Exhibit B-53: CNW Alternative  
Road Standard Request (June 14,  
2019)

**Subject:       Alternative Road Standard Request  
                  Grip Road Gravel Mine Access Road  
                  Mining Special Use Permit PL16-0097  
                  Concrete Nor'west and Miles Sand & Gravel**

To: Paul Randall-Grutter, PE – County Engineer, Skagit County Public Works  
From: Matthew Palmer, PE *MP*  
Subject: Traffic Study Review  
Project: Grip Road Gravel Pit, GTC #17-161  
Date: December 18, 2018

## **SIGNAGE PLAN** **STATION 15+00 TO 30+00**

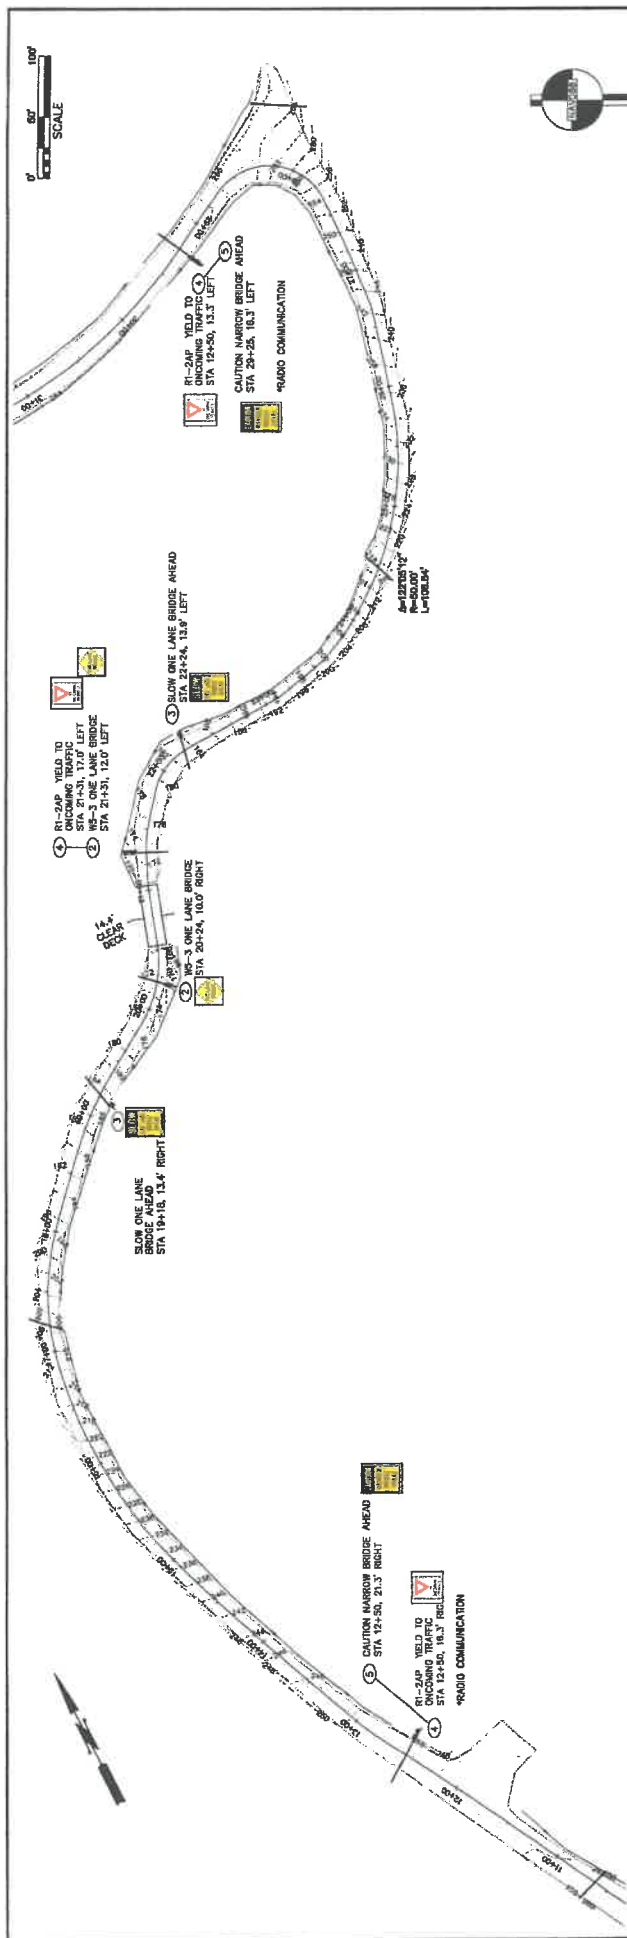
Included for review is the Grip Road Gravel Mine Access Road As-Built drawings (September 13, 2018), both in plan and profile. On Sheet C10 of this plan set is a proposed signage plan intended as an engineered alternative that fully meets the safety, function, appearance, fire protection and maintainability as outlined above for the alternatives and minor deviation to the width, slope and the one-lane bridge.
